**Marion County  
Board of County Commissioners**

**PLANNING & ZONING SECTION  
STAFF REPORT**

<b>P&amp;ZC Date: 04/29/2024</b>	<b>BCC Date: 05/21/2024</b>
<b>Case Number:</b>	240506ZP	
<b>CDP-AR:</b>	31123	
<b>Type of Case:</b>	<b>Rezoning</b> from Community Business (B-2) to Planned Unit Development (PUD) for multiple use development including 30 dwelling units (1.625 acres) and commercial use (7.1 acres).	
<b>Owner</b>	A. Saldarriaga Trust, and Whitehill of Ocala, LLC	
<b>Applicant</b>	CORTA Ocala, LLC	
<b>Street Address</b>	Vacant (No Assigned Address)	
<b>Parcel Number</b>	Numerous (3501-200-018,019,020,021,022 & 023; 3501-200-034, 035, 036, 037, 038, 039 & 040)	
<b>Property Size</b>	±8.76 acres	
<b>Future Land Use</b>	Commercial (COM)	
<b>Zoning Classification</b>	Community Business (B-2)	
<b>Overlay Zone/Scenic Area</b>	Urban Growth Boundary, Secondary Springs Protection Zone, and portions in FEMA Flood Zone A/AE and X	
<b>Staff Recommendation</b>	<b>Approval with Conditions</b>	
<b>P&amp;ZC Recommendation</b>	<b>TBD</b>

**Figure 2  
Conceptual Plan**

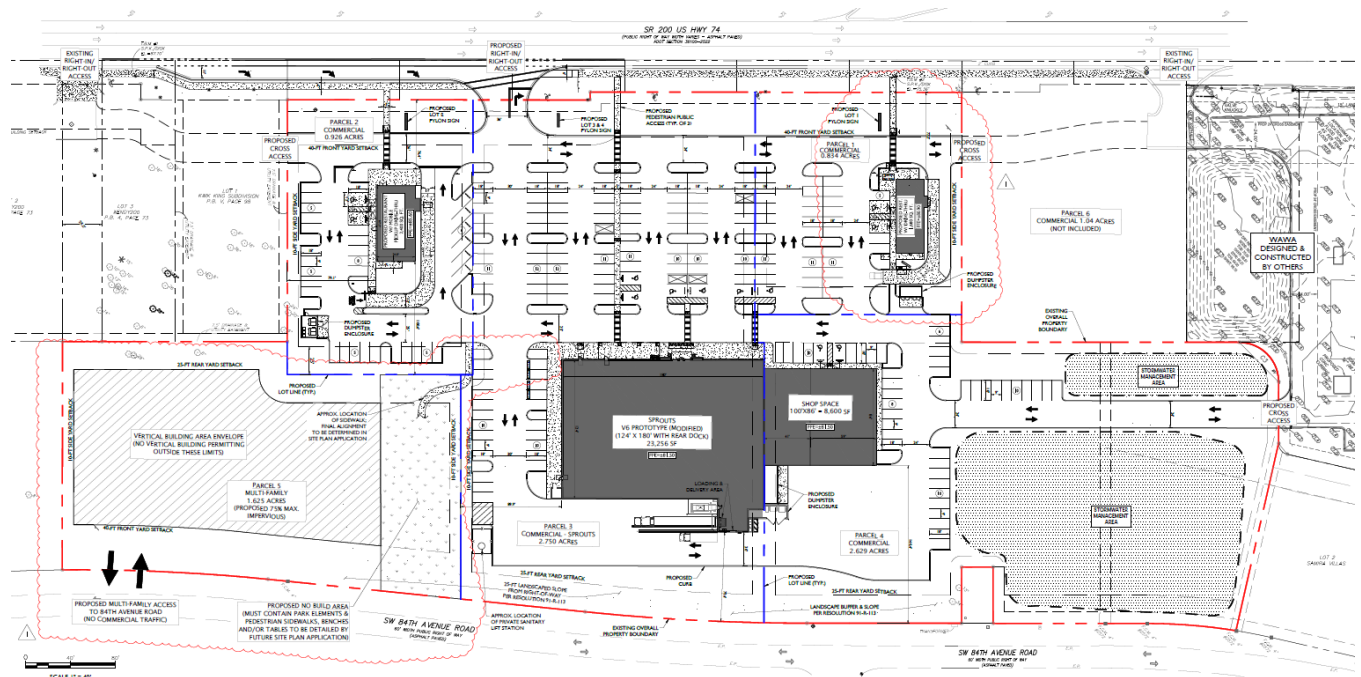
**Analysis:** Access to the property is shown on the conceptual plan. There are three access points to paved SW 99<sup>th</sup> Street Rd through two unnamed roads. Both unnamed roads shown on the conceptual plan are paved. All roads within the PUD will be paved. The location and improvements of access points will have to be worked out through the Development Review phase of site planning. Notwithstanding, staff recommends the following conditions be imposed:

**Analysis:** Staff finds PUD proposes sidewalks along SW HWY 200 and some of internal roads. However, there is no multimodal facilities shown on the conceptual plan. Accessible sidewalk, bike lane, golf cart lane, and multimodal facilities would be recommended to provide on the property. There is no existing sidewalk along SW 84<sup>th</sup> Avenue Road. Applicant will request a sidewalk waiver along this road. A pedestrian connection between the residential and commercial is proposed on the conceptual plan. Staff recommends the following conditions be imposed:

**Analysis:** Staff finds the conceptual plan does not depict any easements. If provided any easements required for maintenance and upkeep of the PUD infrastructure will be determined during the Development Review phase of the process. Staff also finds the applicant is negotiating with the property owners to the west of the property to obtain an agreement of using the right of way and intersection to access SW HWY 200.

**Analysis:** Staff finds that the conceptual plan shows the buildable areas but does not depict any easements. Any easements required will be determined during the Development Review phase of the process.

**Analysis:** Proposed setback has been provided and shown on the Concept Plan (see Attachment A). However, the typical illustration and table are not provided in the submittal. It proposed the setback for front as 40', rear as 10', and side/side yard as 25'. This setback applies to both commercial and residential structures. The setback between parcel 3 and 4 have zero setback, which is acceptable since two parcels are both for commercial shops. Proposed setbacks are more than the LDC requires for residential development standards and meet the requirement for B-2 zoning classification.

**Analysis:** Proposed elevations have been provided for commercial structures. (See Attachment) Building height limitation is shown on the Concept Plan (see Attachment A). However, the typical illustration and table are not provided in the submittal.

- Show multimodal facilities on the PUD Master Plan. Include multimodal path for pedestrians, bikes, and golf carts externally and internally.
- Show accessible pedestrian connections from PUD area to all adjacent land uses on the site plan.

- Show accessible sidewalks along at least one side of internal roads and connections to multimodal paths.
4. LDC Section 4.2.31.E.(1)(d) provides parking and loading spaces shall be provided consistent with the requirements for developed uses as listed in Section 6.11.8; however alternative parking and loading standards may be proposed, provided such standards are based on accompanying technical information and analysis provided by a qualified professional. The use of shared parking is encouraged, along with the integration of parking as part of a multi-use structure as provided in Section 4.2.6.D.(8).

- An easement agreement with the property owners to use the cross-access through adjacent properties shall be obtained before the site plan is approved.
2. LDC Section 4.2.31.E.(2)(b) provides no principal or accessory structure may be erected, placed upon, or extend over any easement unless authorized in writing by the entity holding title to said easement, with such authorization being recorded in the Marion County Official Records. Such authorizations may include, and are encouraged to set forth, terms and conditions, regarding the easement encroachment (e.g., duration, maintenance, removal, sunset, etc.) for reference by all current and future parties.

- On the Master Plan provide a typical illustration and table showing all setbacks.
2. LDC Section 4.2.31.E.(3)(c) provides building pop-outs, cantilevers, and/or other extensions that project outward from the principal structure, particularly those that make up habitable space, shall comply with established principal structure setbacks; however, the PUD may propose authorized encroachments not to exceed two feet into any setback, subject to compliance with building construction standards (e.g., fire code) for the encroachment structure, except no encroachment into an established front yard setback is permitted.

- On the Master Plan provide a typical illustration and table showing a maximum height limits for principal and accessory structures.
